10/757,821

Office Action Summary

DETAILED ACTION

CHANG FIGURES

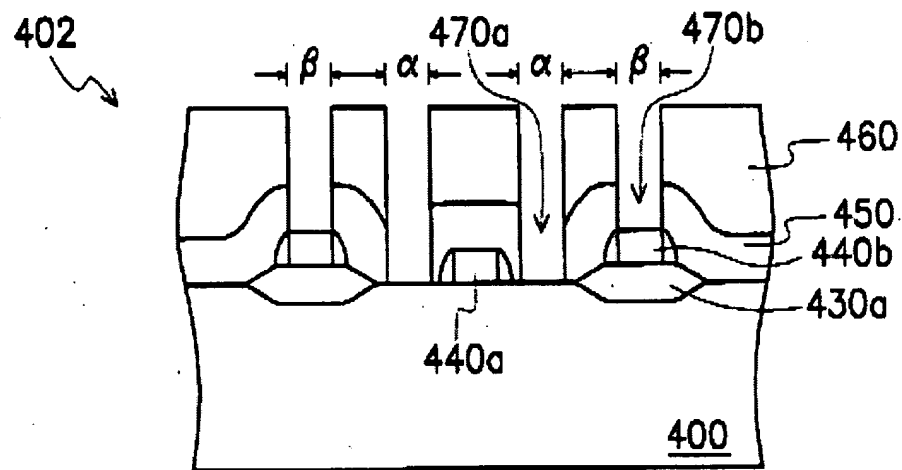
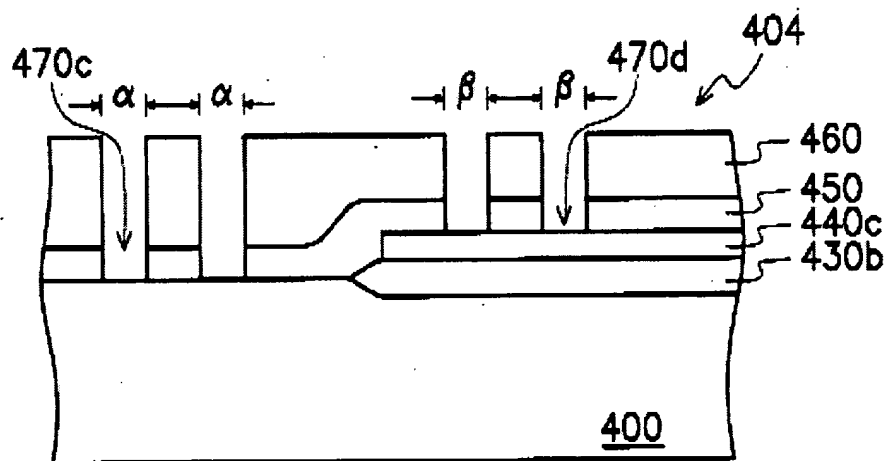
Claims 1 and 2 are rejected under 35 U.S.C. 103(a) as being unpatentable over Chang et al, US Patent 6,350,994 and Goto et al, US Patent Application Publication 2002/0105041. See Chang and Goto figures below.

Regarding claim 1, Chang teaches a method of making a monitoring pattern of a shallow trench isolation profile comprising of forming a first pattern **710a**, **710d** on a substrate to monitor a depth of a first shallow trench isolation and forming a second

pattern **710b**, **710c** on the substrate to measure electrical effects associated with a depth and a profile of a second shallow trench isolation, wherein the second pattern includes a plurality of equally spaced active regions on the substrate

Chang fails to teach the first pattern includes a plurality of unequally spaced active regions on the substrate and a plurality of contact regions that electrically connect the equally spaced active regions. Goto teaches the first pattern includes a plurality of unequally spaced active regions on the substrate (Note: Goto teaches unequal active region since the source/drain, found in the active region of the substrate, are different sizes. The use of the spacing of the photoresist as taught in Chang with the device taught by Goto would meet this limitation as set forth) and a plurality of contact regions that electrically connect the equally spaced active regions (source and drain regions, which are well-known in the art). It would be obvious to one skilled in the art to combine the teachings of Goto with that of Chang because in an integrated circuit, third transistors having the thickest gate insulation film are driven at high voltage and thus operate at high speed with minimal gate leak current (Goto, abstract).
